RHODE ISLAND CONTRACT NO.2020-CB-015

Bridge Group 10 - I-295

NOTICE TO PROSPECTIVE BIDDERS

ADDENDUM NO. 3 Prospective bidders and all concerned are hereby notified of the following changes in the Plans, Specifications, Proposal and Distribution of Quantities for this contract. These changes shall be incorporated in the Plans, Specifications, Proposal and Distribution of Quantities, and shall become an integral part of the Contract Documents.

RI CONTRACT NO.
 2020-CB-015
**SKETCH NO.
 1**

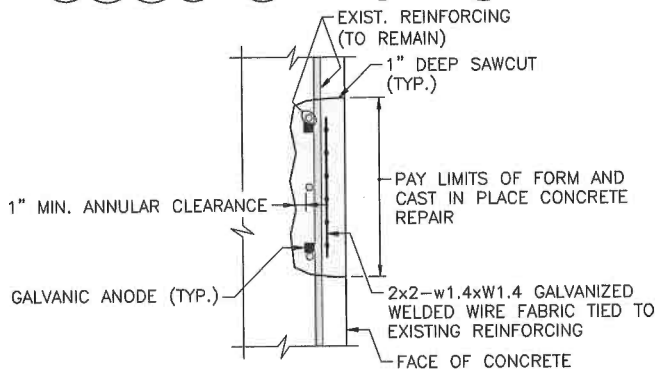
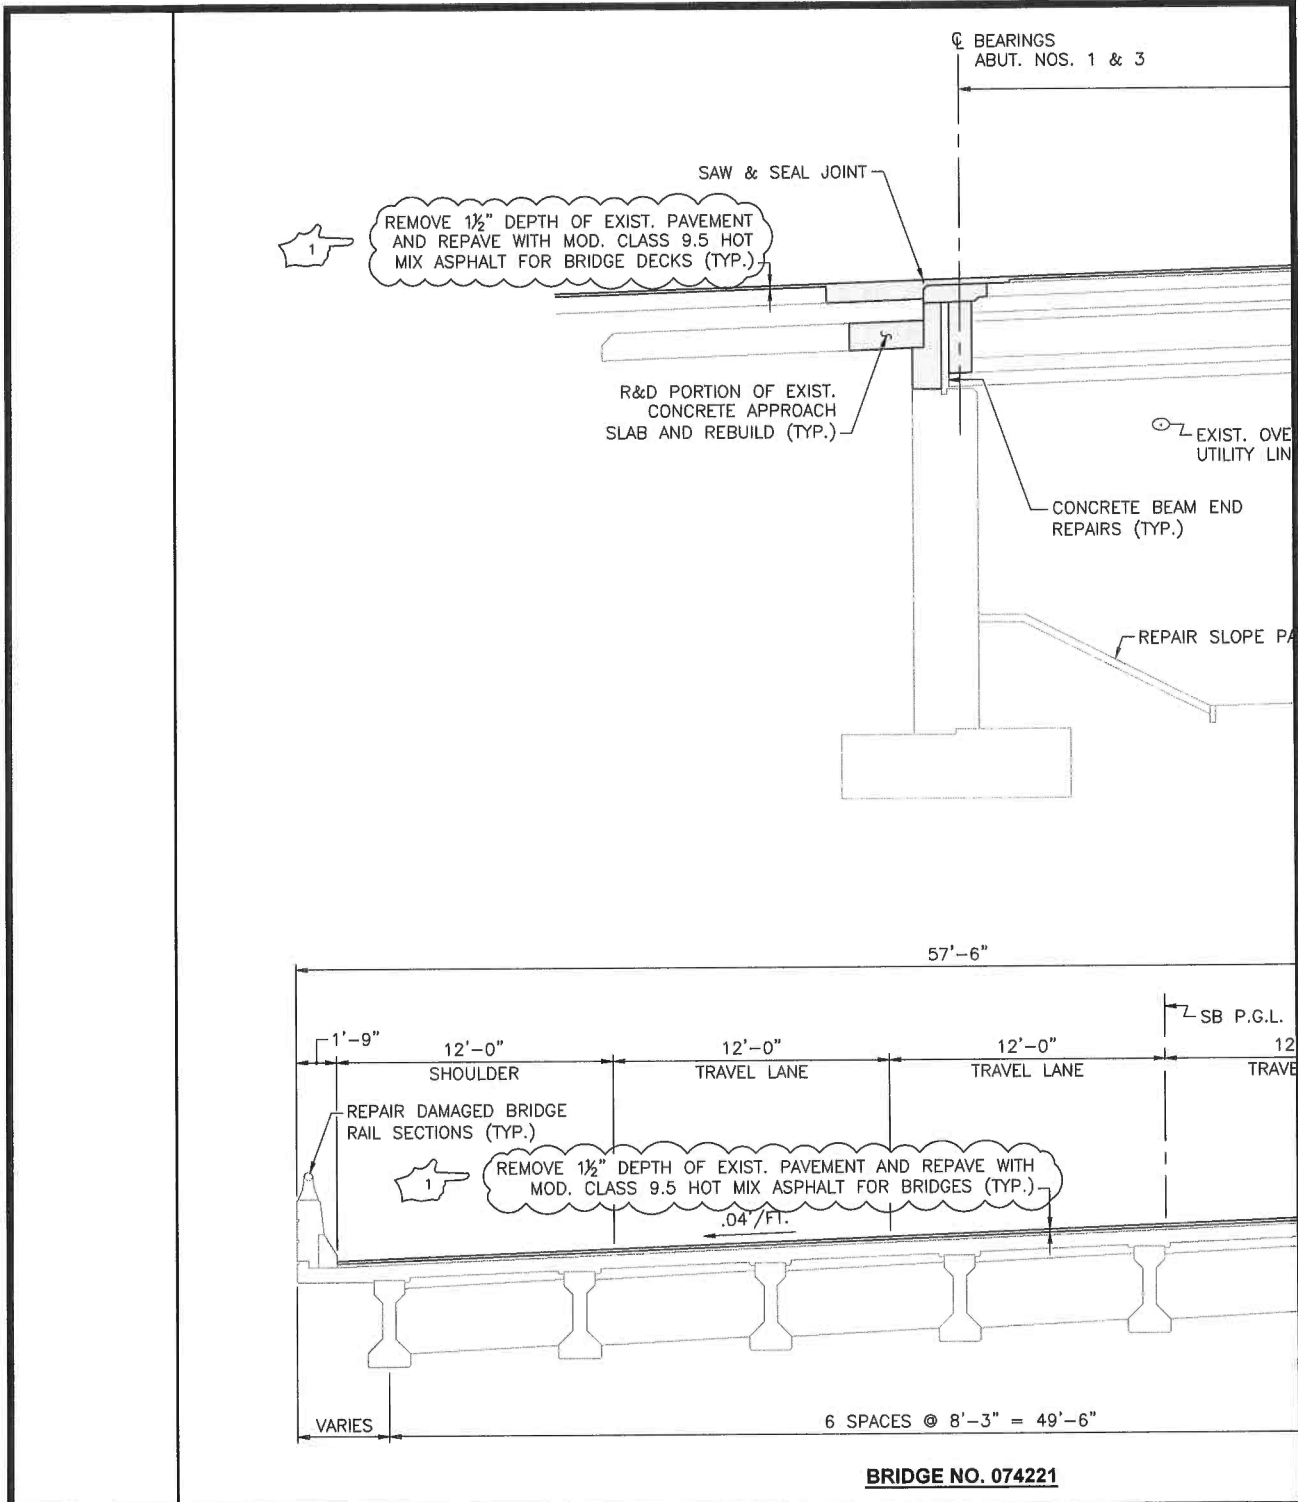
Revise Sheet No. 11 as shown on Sketch Nos. 1(R-1) and 2(R-1) attached to this Addendum No. 3. A note regarding spacing of galvanic anodes has been added and payment for welded wire fabric and galvanic anodes has been changed.

GALVANIC ANODES SHALL BE SPACED EVENLY AROUND THE PERIMETER OF THE REPAIR AREA AT A MAXIMUM SPACING OF 24" O.C. IN FACES OF WALLS AND ABUTMENTS.

SKETCH NO.
3

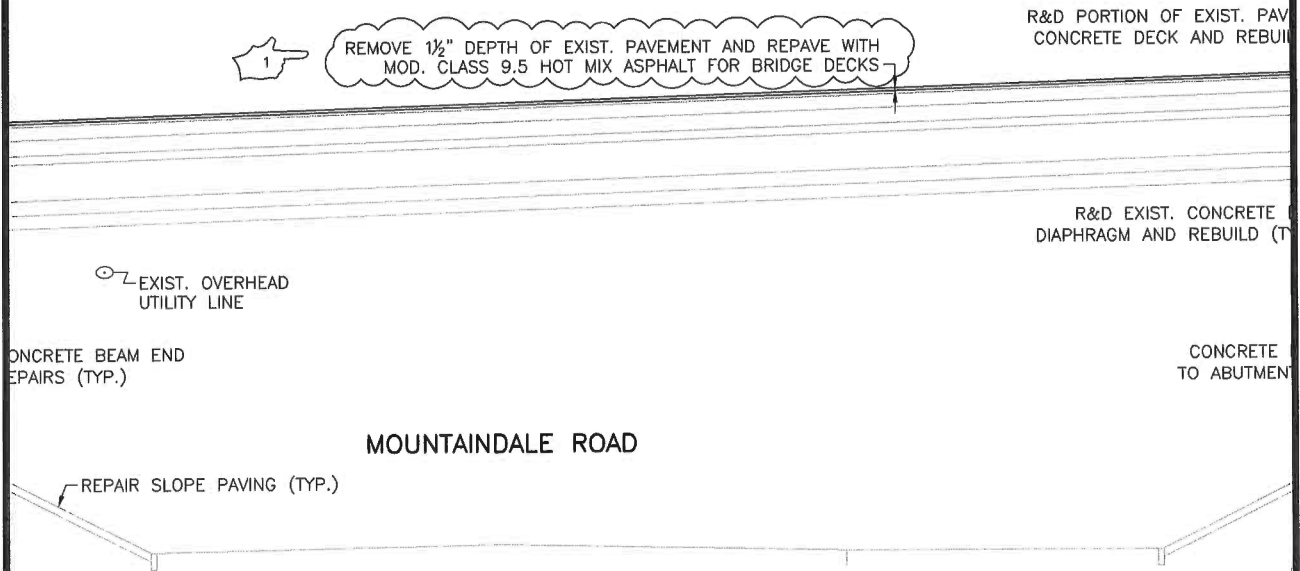
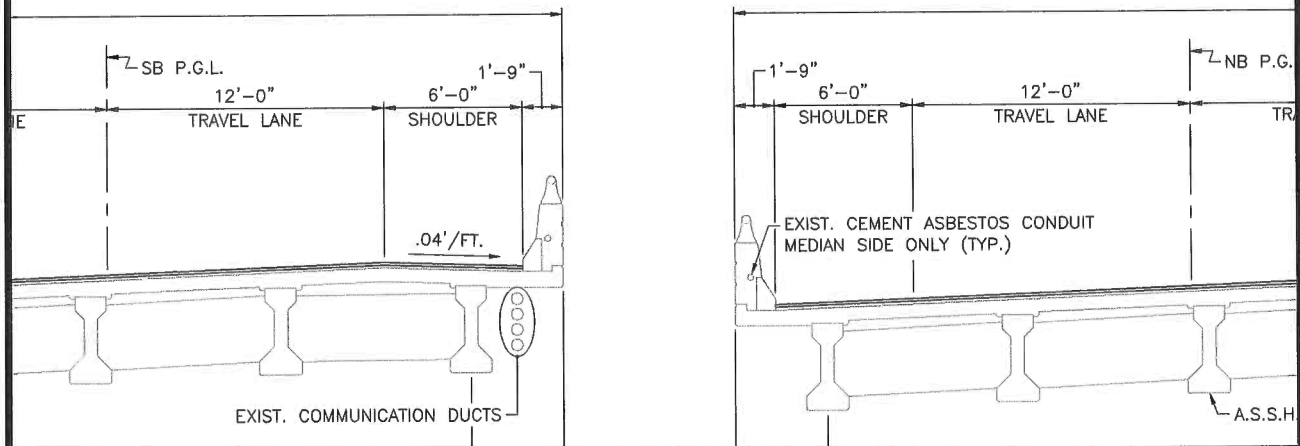
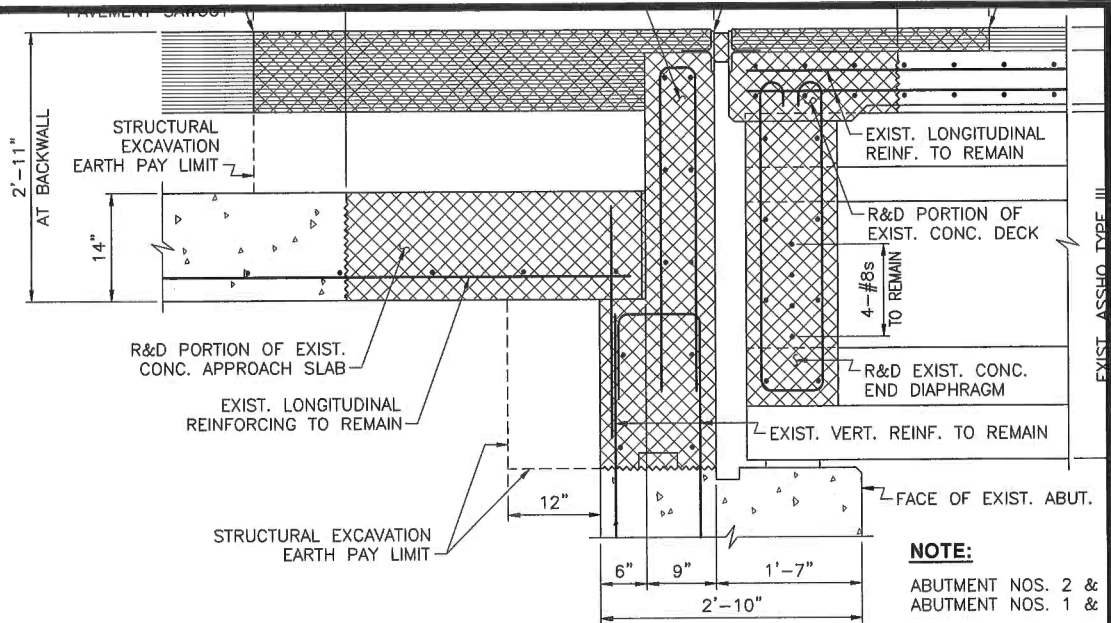
Revise Sheet No. 13 as shown on Sketch Nos. 3(R-1) and 4(R-1) attached to this Addendum No. 3. The pavement structures at approaches and on the bridge have been changed.

RI CONTRACT NO.
2020-CB-015
SKETCH NO.
5

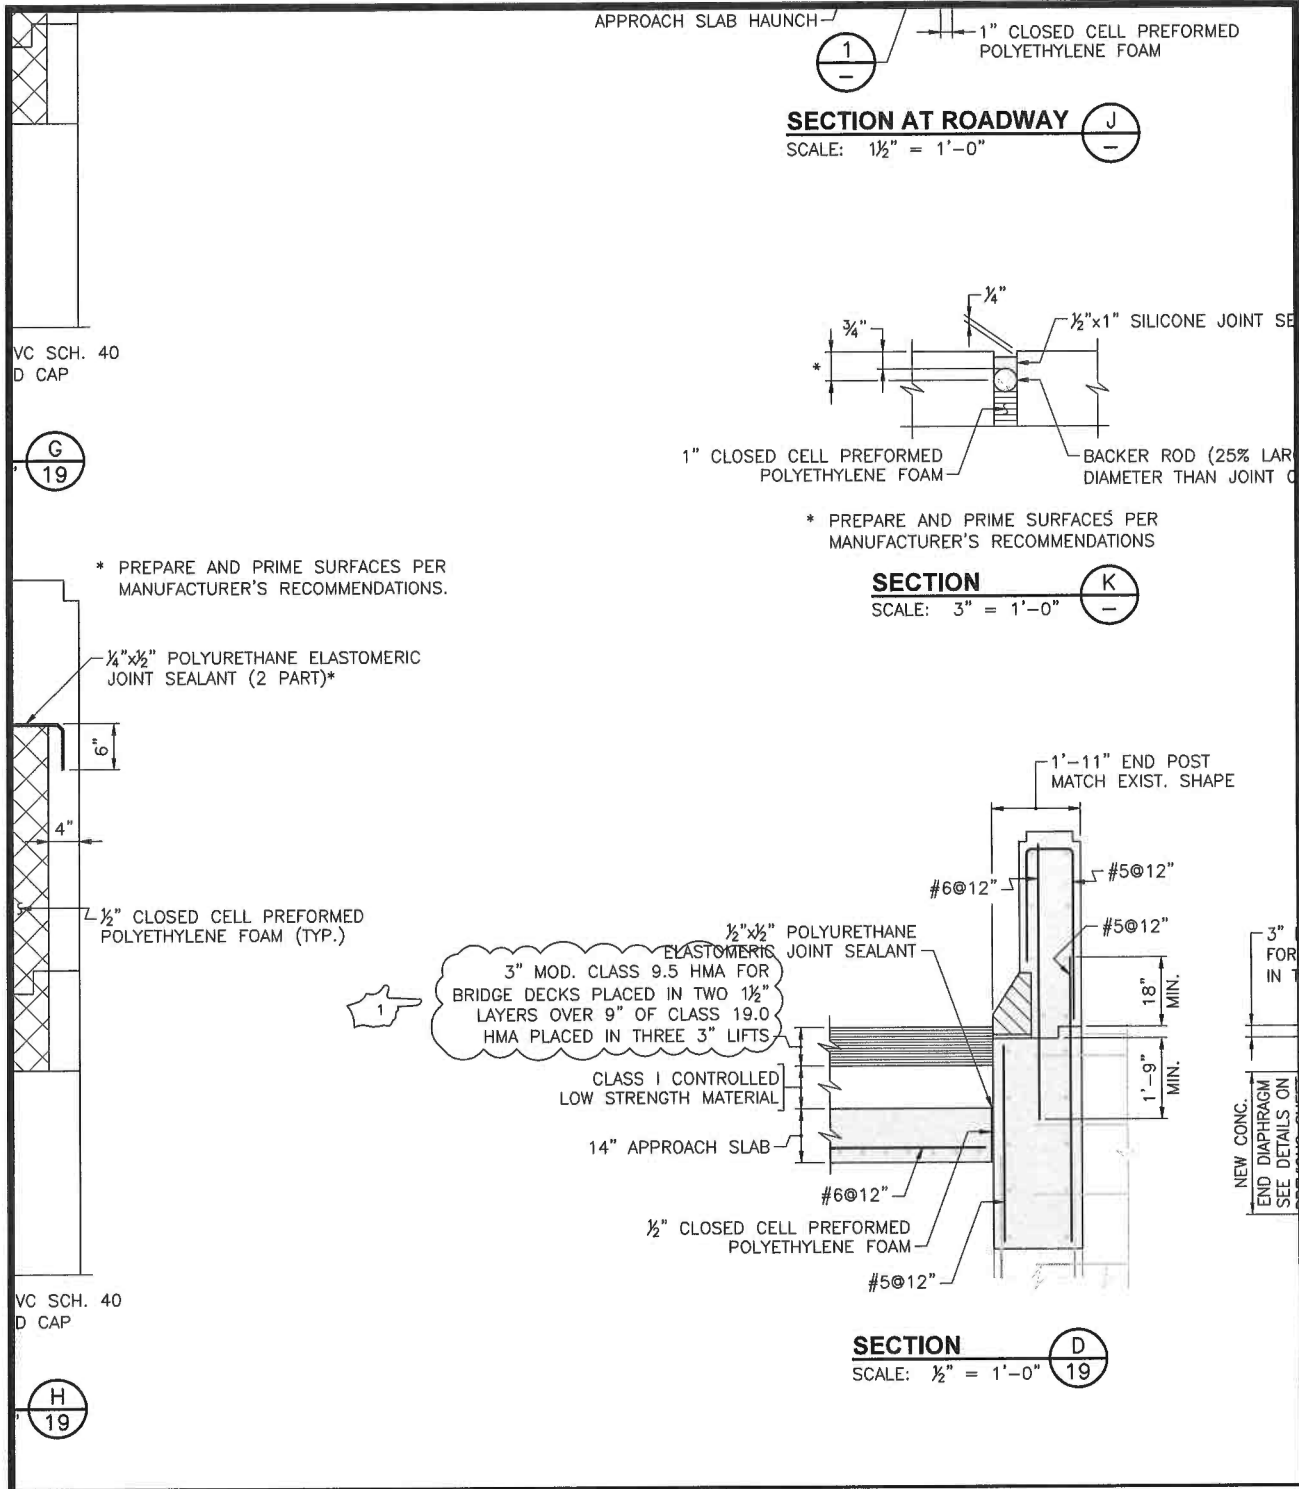
Revise Sheet No. 17 as shown on Sketch Nos. 5(R-1) and 6(R-1) attached to this Addendum No. 3. Sequence for Bridge Joint Work and Repaving Note No. 4 has been revised and the pavement structure at approaches has been changed.

1. REMOVE AND DISPOSE MATERIALS AS CALLED FOR IN THE DETAILS.
2. RECONSTRUCT APPROACH SLAB, WITH NEW HAUNCH, BACKWALL, WINGWALL, DECK OVER BACKWALL, AND BARRIERS, AS CALLED FOR IN THE DETAILS.
3. INSTALL NEW WATERPROOFING MEMBRANE AND REPAVE (FULL DEPTH)
4. AFTER FULL WIDTH OF BRIDGE JOINT WORK HAS BEEN COMPLETED, REMOVE 1½" DEPTH OF PAVEMENT ON THE BRIDGE AND APPROACHES, CLEAN & SWEEP THE SURFACE, APPLY TACK COAT, AND REPAVE WITH 1½" DEPTH OF MOD. CLASS 9.5 HOT MIX ASPHALT FOR BRIDGE DECKS.
5. AT ABUTMENT NOS. 1 & 3, SAWCUT & SEAL JOINT.
6. AT ABUTMENT NOS. 2 & 4, SAWCUT & REMOVE 1'-8" (NOMINAL) WIDTH OF PAVEMENT AND INSTALL NEW ASPHALTIC JOINT MATERIALS.

SKETCH NO.
7

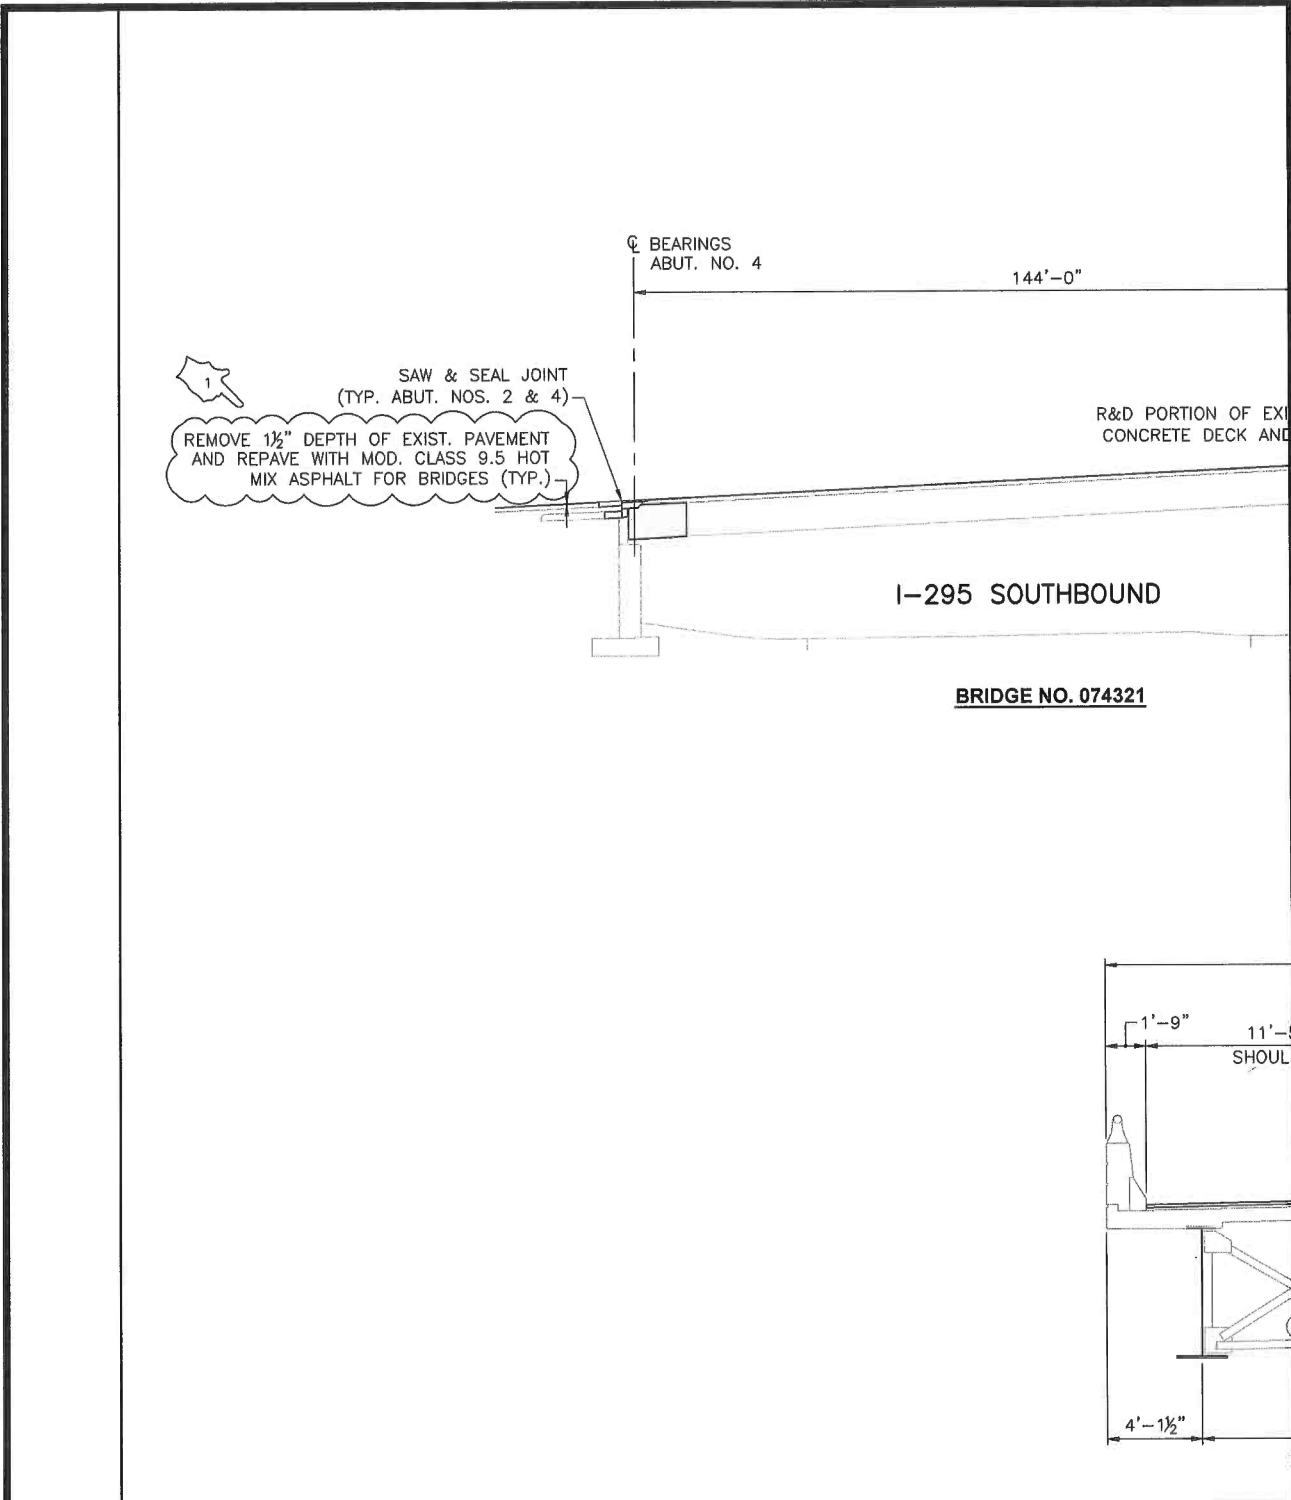
4. Sheet No. 20 - Mountaindale Road Bridge Nos. 074201 & 074221 - Joint Details - 4
Revise Sheet No. 20 as shown on Sketch No. 7(R-1) attached to this Addendum No. 3. The pavement structure at approaches has been changed.

TITLE OF SKETCH
BRIDGE GROUP 10 - I-295
FARNUM PIKE BRIDGE NOS. 074301 & 074321
BRIDGE TYPICAL SECTIONS

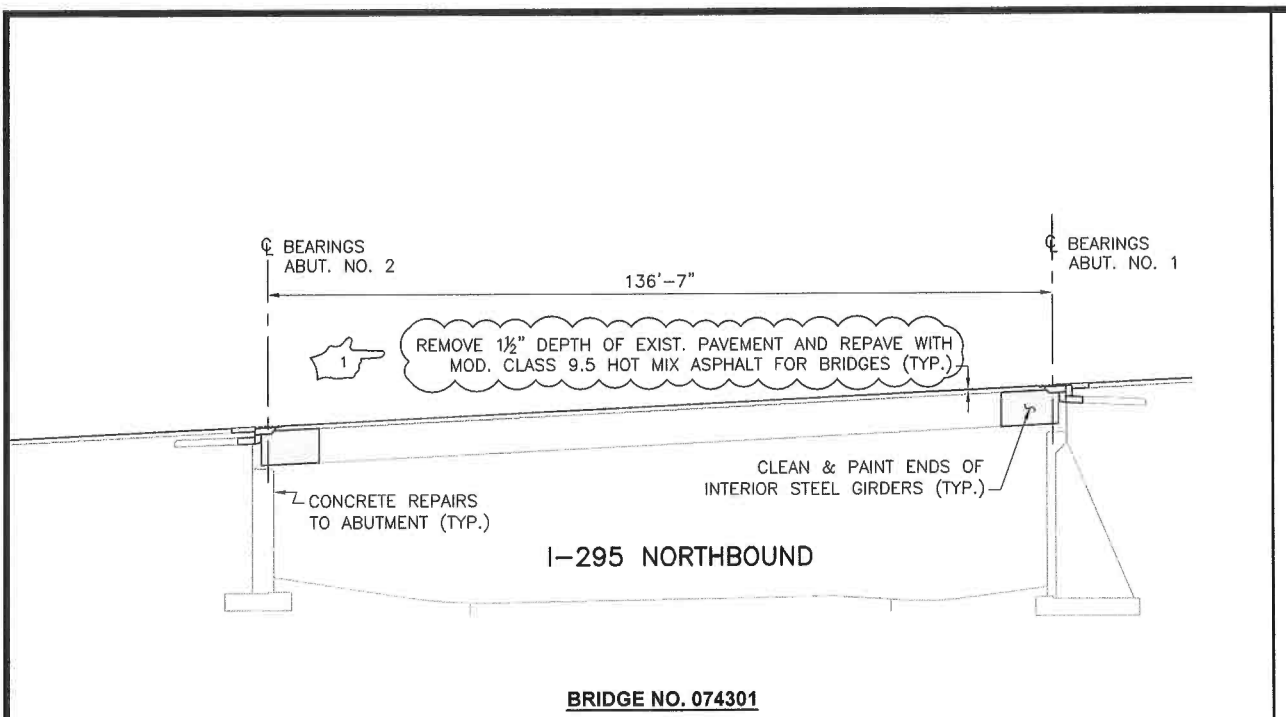
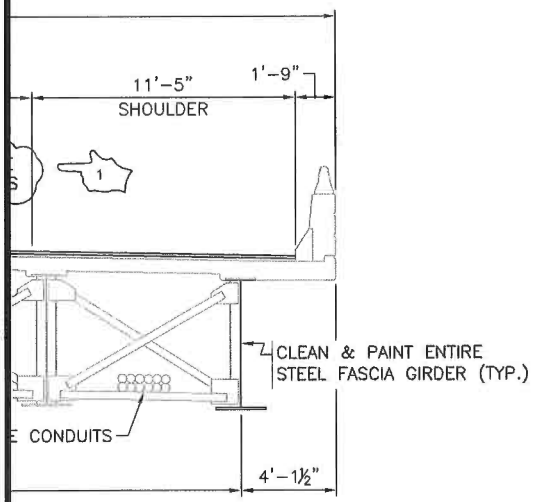
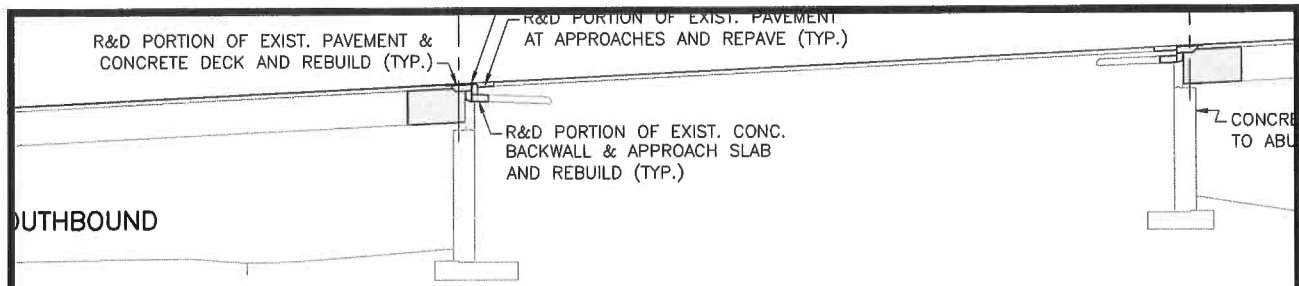
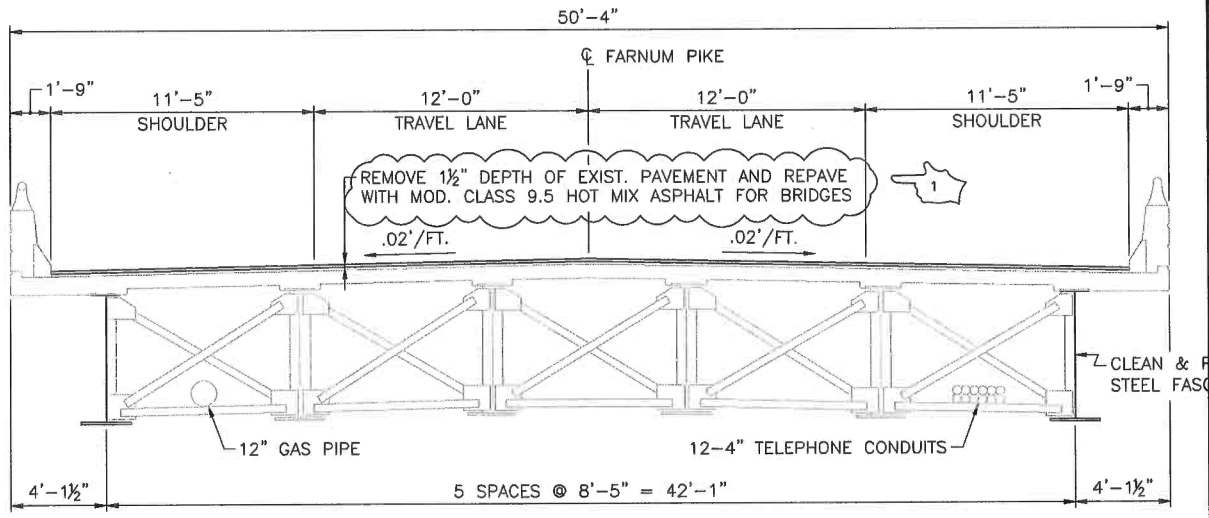
5. Sheet No. 23 - Farnum Pike Bridge Nos. 074301 & 074321 - Bridge Typical Sections
Revise Sheet No. 23 as shown on Sketch Nos. 8(R-1) through 10(R-1) attached to this Addendum No. 3. The pavement structures on the approaches and the bridges have been changed.
